February 16, 2023

RE: 22-125120-PLN
Reid Saunders Association
3985 Lindburg Road SE
Salem, OR 97302

We wish to express our appreciation for your timely review of the Construction Documents for Reid Saunders Association. Attached is your Plan Review Comments, and following are our proposed responses.

1 SITE PLAN
SCALE: 1"=20'-0"

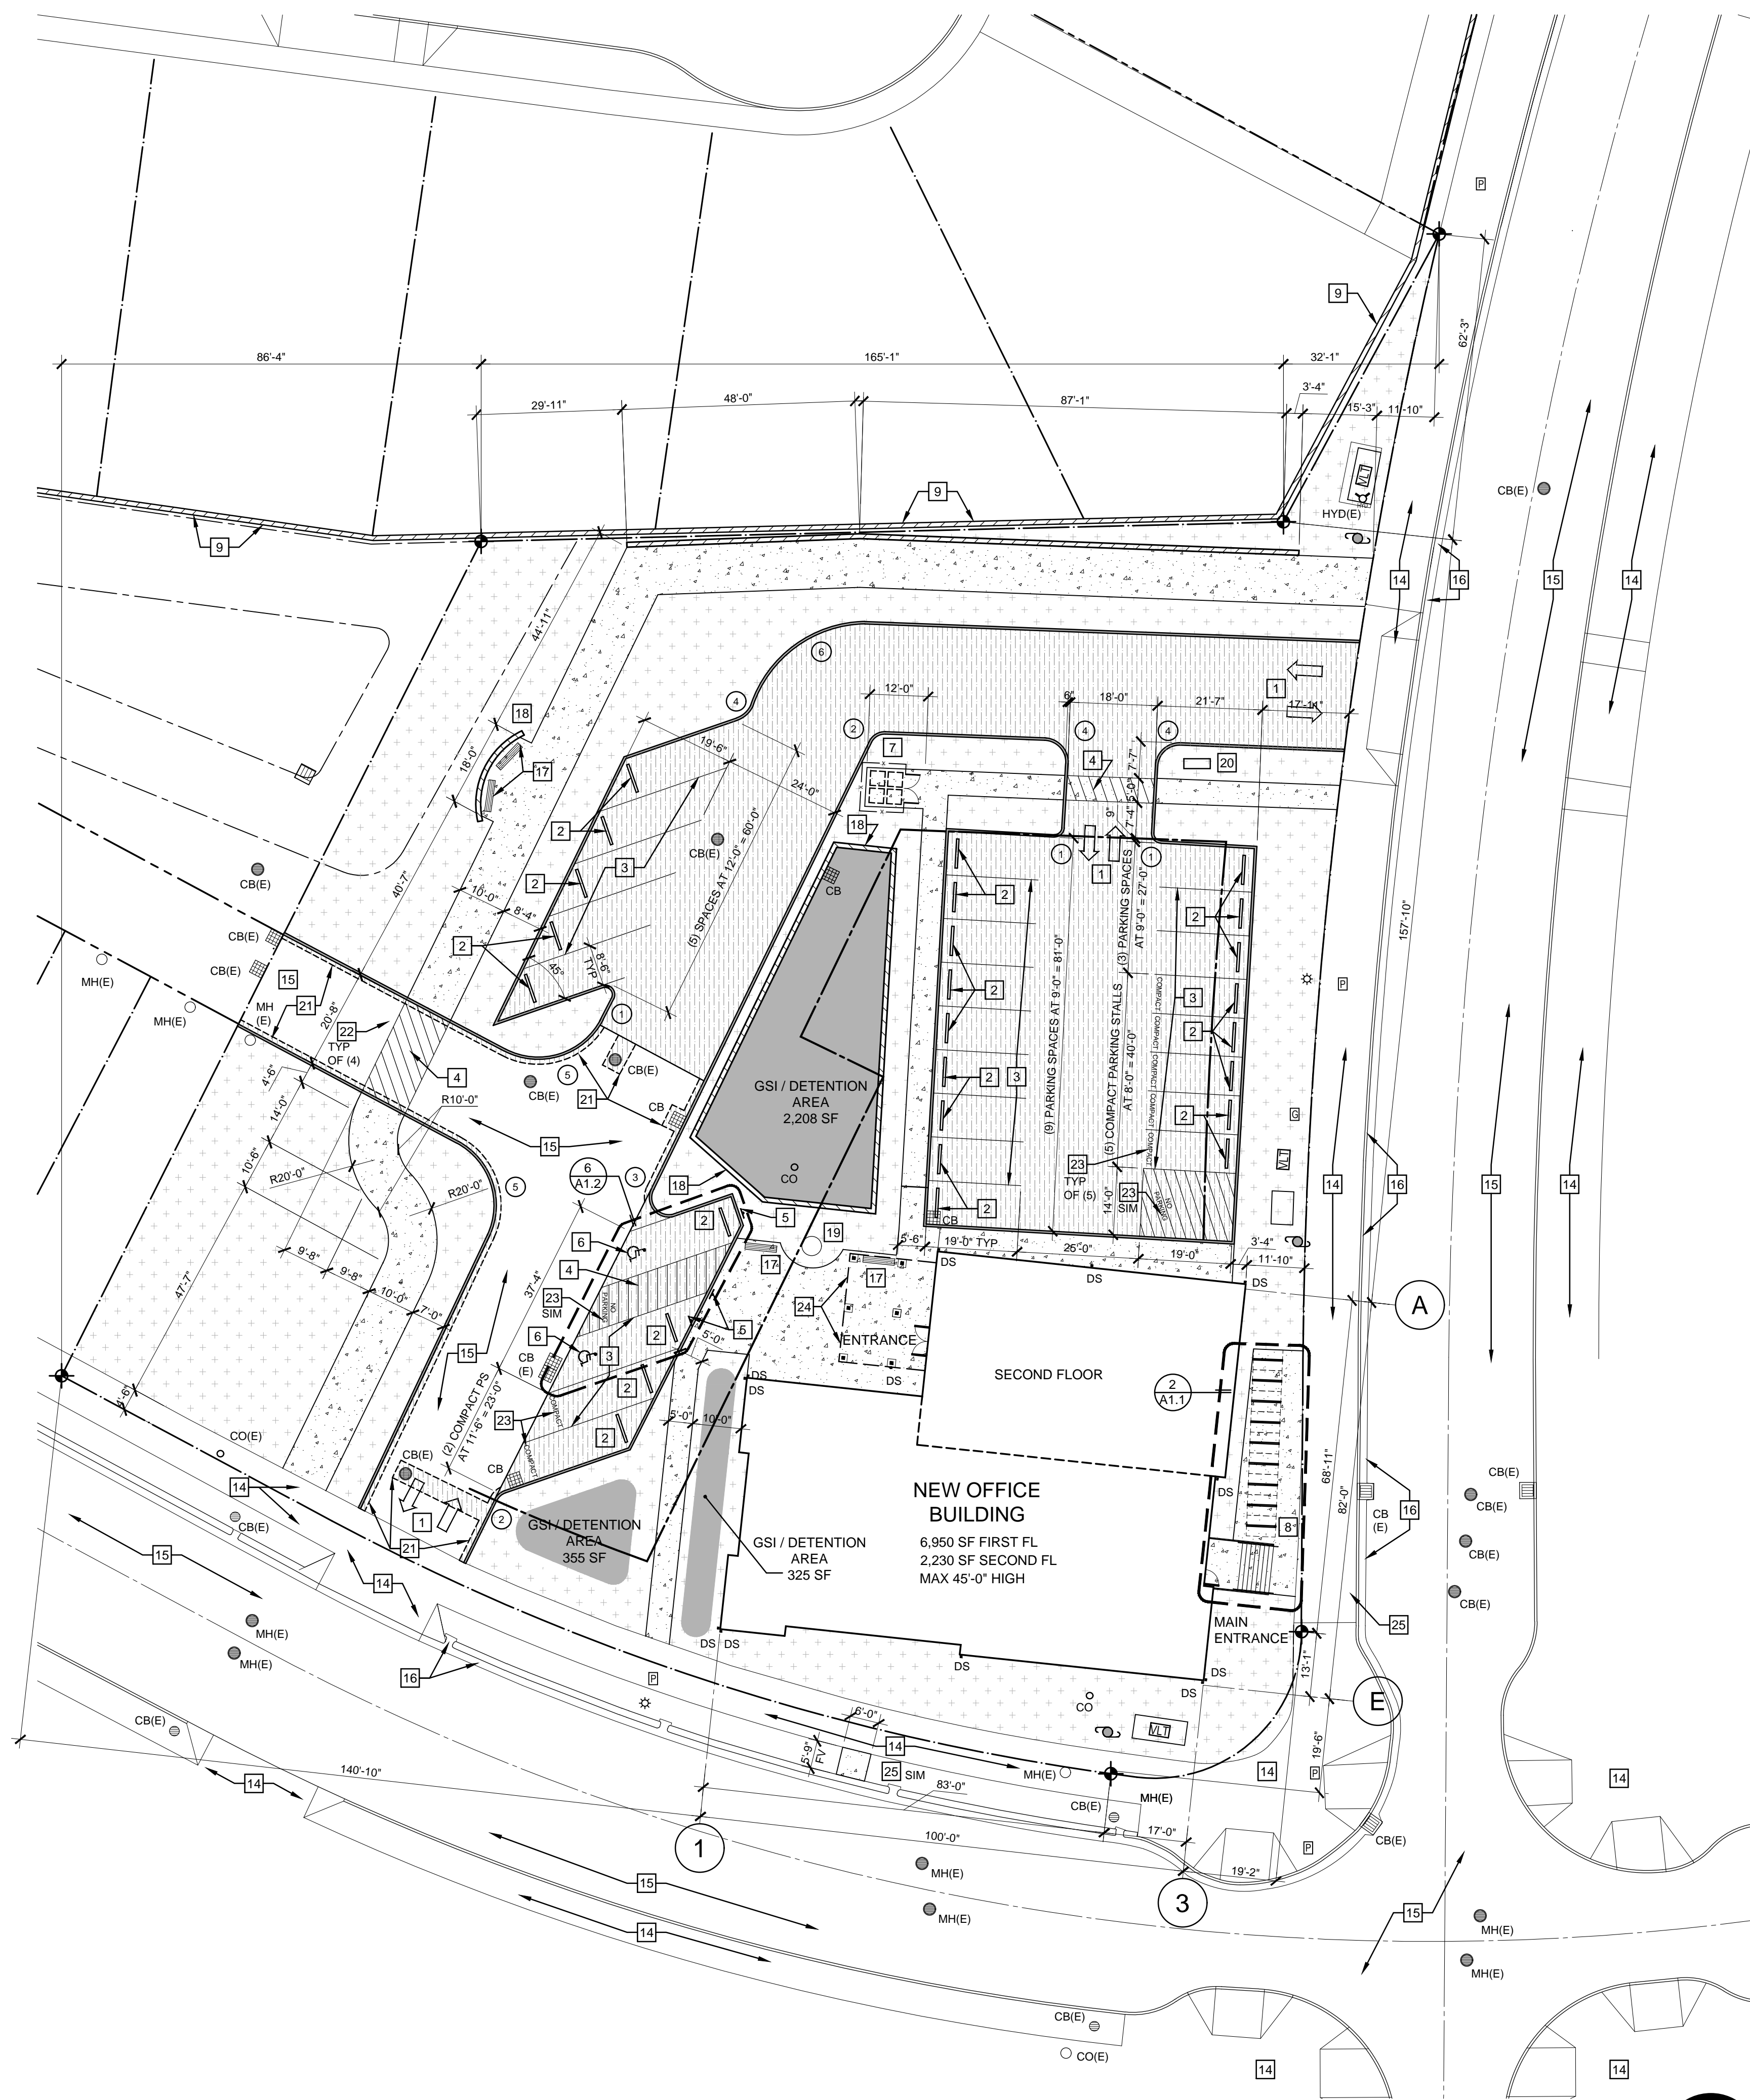
5. Confirmation of Proposed Use:
 - a. Confirmed, the proposed use of this development is office use.
6. Site Plan:
 - a. A revised site plan is attached with dimensions to the property lines, refer to Sheet A1.1.

7. Elevations:
 - a. Building elevations are attached, refer to Sheet A3.1.
8. Transit Improvements:
 - a. Two Cherriots stops are now provided on the revised site plan. Refer to the attached Sheet A1.1.

11. Additional Comments on Plan:
 - a. The site plan on Sheet A1.1 has been updated to reflect the markups.
